Our Ref: 25544-191-01  
Your Ref: MCU26/0008

**RESPONSE TO INFORMATION REQUEST  
DEVELOPMENT APPLICATION FOR MATERIAL CHANGE OF USE (MCU26/0008)  
74 MAIN STREET, BURDELL (LOT 857 ON SP359106)**

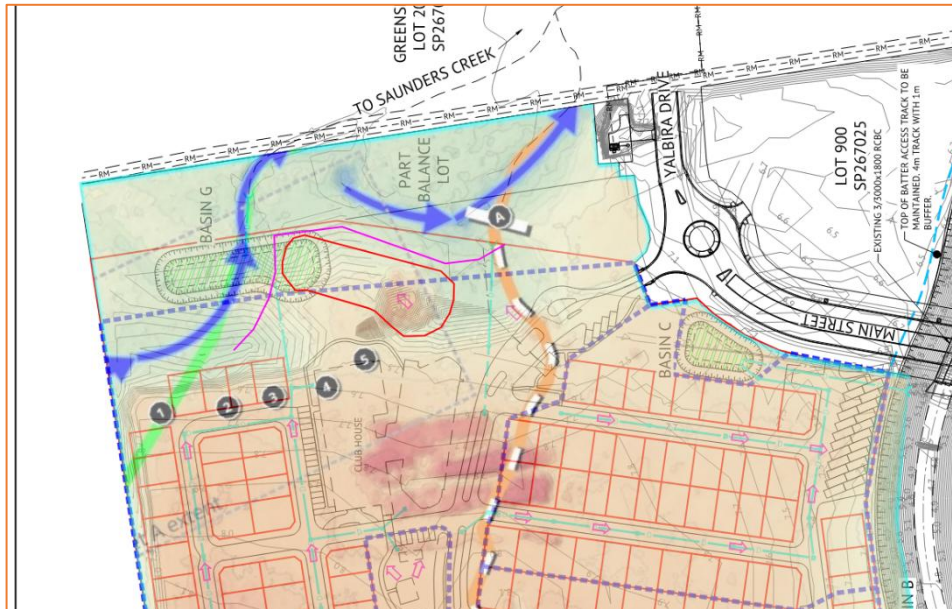
- *A 1% AEP climate change scenario is requested to be provided for the post-development scenario. The report to discuss any significant changes when compared with the 1% AEP post-development present-day scenario.*
- *Confirmation that bio-retention Basin G will be provided with suitable regional flood immunity and will not be subject to excessive inundation.*

With respect to the second dot point, it is noted that Bioretention Basin G will be relocated further east through the detailed design phase and is considered to have suitable separation clearance from regional flood flow paths. Additional details will be provided during the detailed design stage and submitted as part of the Operation Works Application for approval by Townsville City Council. See sketch below.
